Project Name: Four Square - Flood Plain Permit

FLOOD AND DRAINAGE ANALYSIS  
FOR  
WESTWOOD  
PLANNED DEVELOPMENT

REVIEW SHEET

Re: Horizon Drive Channel Fill  
Four Square Church  
#792430

WESTERN ENGINEERS, INC  
 ENTRY ROAD & CULVERT  
 GRADING PLAN  
 WESTWOOD

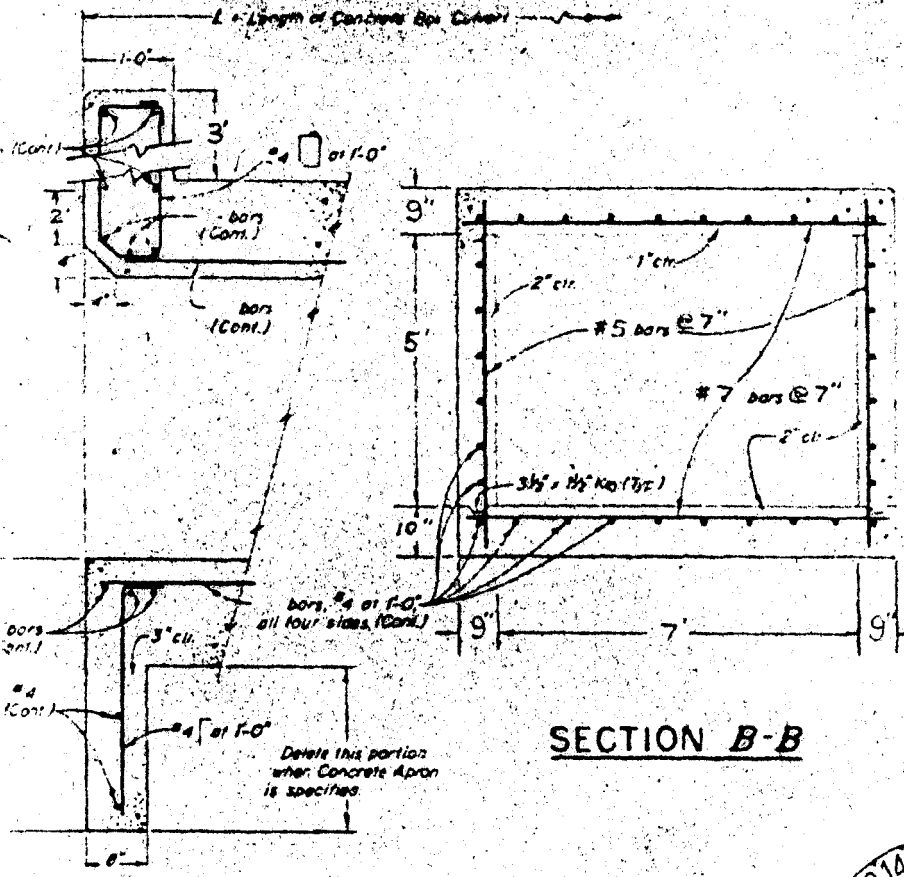
- \*Comments:
- ① Western Engineers soils report cautions about poor load bearing capacity of site soils and canal seepage problems. Special designs for buildings are recommended and subgrade stabilization with gravel under pavements.
  - ② Power of attorney for full street improvements on Horizon Drive should be granted.
  - ③ A drainage easement should be granted for Horizon channel.
  - ④ I assume there are no public streets in the development and no City maintenance responsibilities.
  - ⑤ "Flood and Drainage Analysis" by Western Engineers as submitted to me on May 14, 1979, predicts 100 year flood depth of 11 ft. at the 5'x7' culverts entrances. Building floor

\*Use additional sheets if necessary and refer to Item #. elevations should be based on this flood potential. Site grading and/or channel filling should not be allowed OVER

create channel "bottlenecks" which would cause any worse backwater condition than the 5'x7' box culverts. Their engineer should control this during design and construction.

## INDEPENDENT RANCHMEN'S DITCH ENCROACHMENT-RECHANNELIZATION

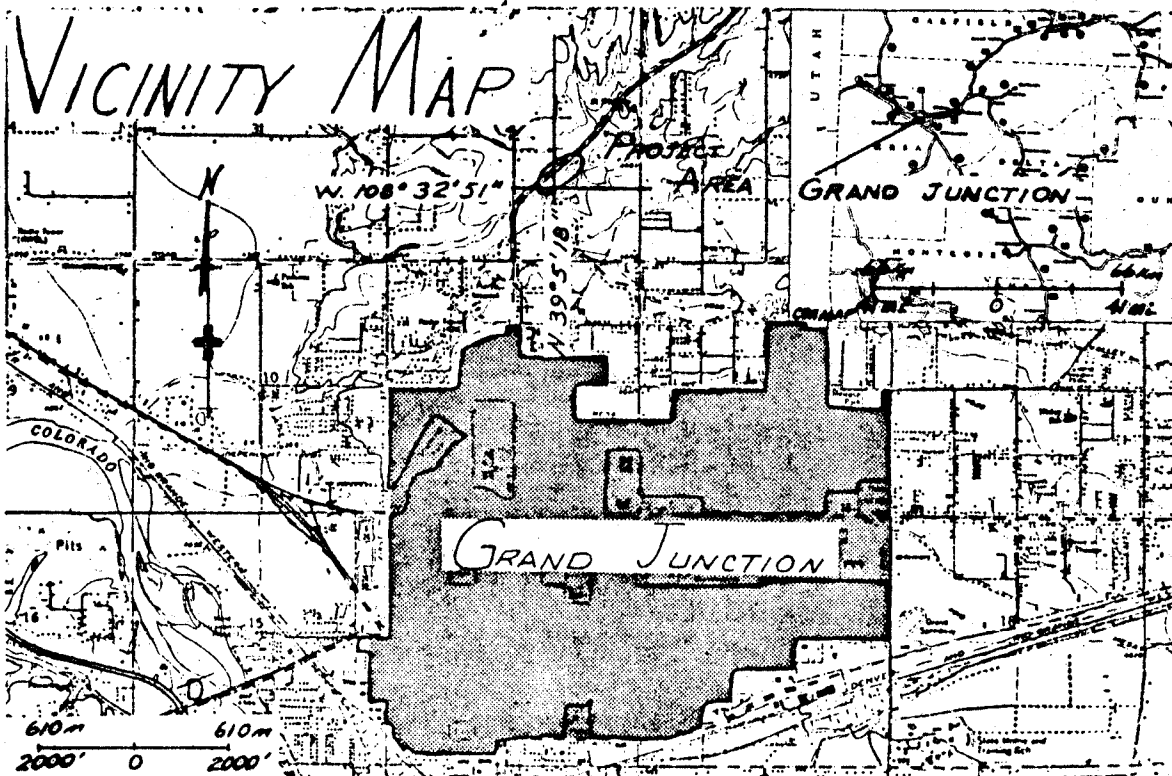
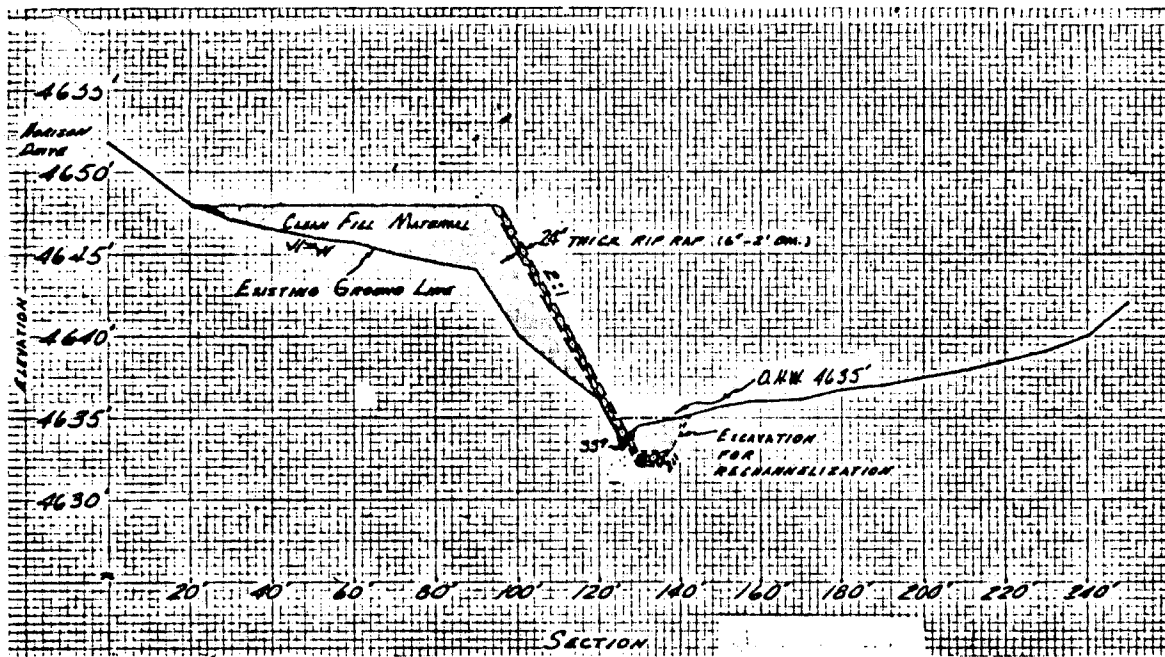
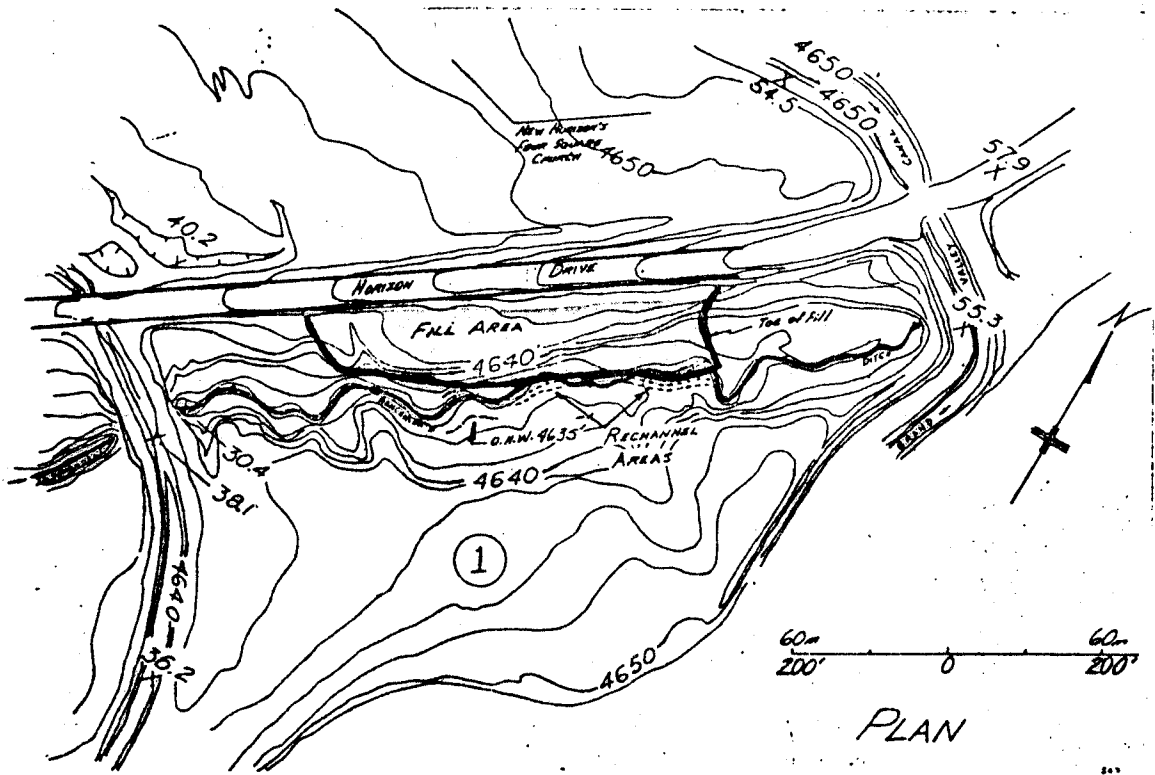
In response to your public notice 6894 you should be aware that a residential project has received final approval on land owned by Mr. T.L. Benson immediately adjacent to the proposed fill/rechannelization area. At the time of processing and approval of the residential project a floodplain analysis including hydrological study was done on the drainage way to insure that there would be no adverse effect of the floodplain on the project or adjacent areas. Any filling or rechannelization of the drainage way should not adversely impact the development right of the approved residential project. It also seems that some portions of the existing channel are on the property owned by Mr. Benson. I question how the rechannelization will affect those portions of channel not on the petitioner's property.
